Access Compliance Report

Public Rights-of-Way

(Curb Ramps)

Intersection ID: 29459	Main Street: N_ALEXANDER_ST	Cross Street: GARDEN_DISTRICT_DR	Location: E
ADA ID: 549E57F5CB8A	Ramp Type: BlendTrans1	Initial Pass/Fail: Fail	Overall Compliance: No
			Severity Score: 21.25

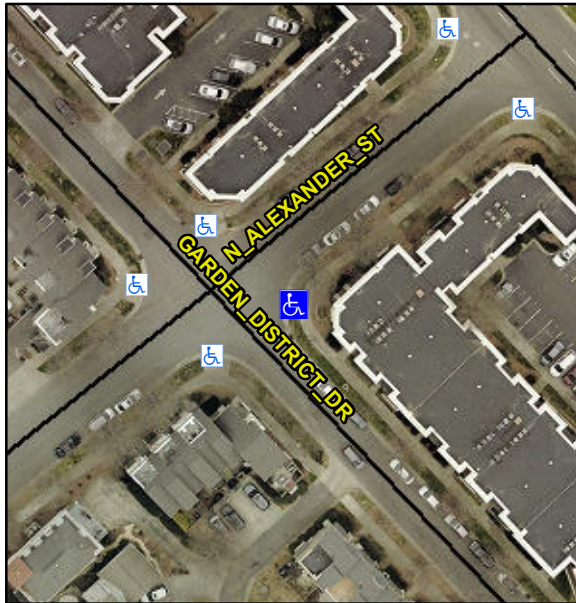
Not Found, R304.5.1, R304.5.3

Compliance	Description	Data	Compliance	Description	Data
N/A	Ramp Length (in)	73.0	Yes	BlendTrans Slope (%)	0.7
No	Ramp Width (in)	47.5	No	BlendTrans XSlope (%)	5.5
N/A	Flare Type LT	N/A	N/A	Flare Type RT	N/A
N/A	Flare Slope LT (%)	N/A	N/A	Flare Slope RT (%)	N/A
N/A	Flare Traversable LT?	N/A	N/A	Flare Traversable RT?	N/A
N/A	Landing Length (in)	N/A	N/A	DWS Provided?	N/A
N/A	Landing Width (in)	N/A	N/A	DWS Contrast?	N/A
N/A	Landing Slope (%)	N/A	N/A	DWS Length (in)	N/A
N/A	Landing X Slope (%)	N/A	N/A	DWS Full Width?	N/A
N/A	Landing Curb? (Y/N)	N/A	N/A	DWS Offset (in)	N/A
N/A	Shared Landing?	N/A			
N/A	Gutter Ponding?	N/A	N/A	Gutter Slope (%)	N/A
N/A	Gutter Lip Ht (in)	N/A	N/A	Gutter X Slope (%)	N/A
N/A	Painted X Walk1?	No	N/A	Painted X Walk2?	No
	X Walk 1 Direction	To NW		X Walk 2 Direction	To SW
	X Walk 1 Width (in)	N/A		X Walk 2 Width (in)	N/A
	X Walk 1 Slope (%)	4.1		X Walk 2 Slope (%)	0.3
	X Walk 1 X Slope (%)	3.0		X Walk 2 X Slope (%)	3.5

N/A	Ramp inside XWalk1?	N/A	N/A	Ramp inside XWalk2?	N/A
	Road Slope (%)	4.9		Clear Space?	N/A
	Road X Slope (%)	0.1	N/A	Clear Space to XWalk (in)	N/A
N/A	Any Obstructions?	N/A	N/A	Storm Grate/Utility Hazard?	N/A
	Obstruction Type			Storm Grate/Utility Type	
		N/A			N/A
			Yes	Surface Condition? (G/P)	Good
			No	Curb Slope (%)	9.5

Remove & Replace Curb Ramp With Two New Directional Ramps or Equivalent.
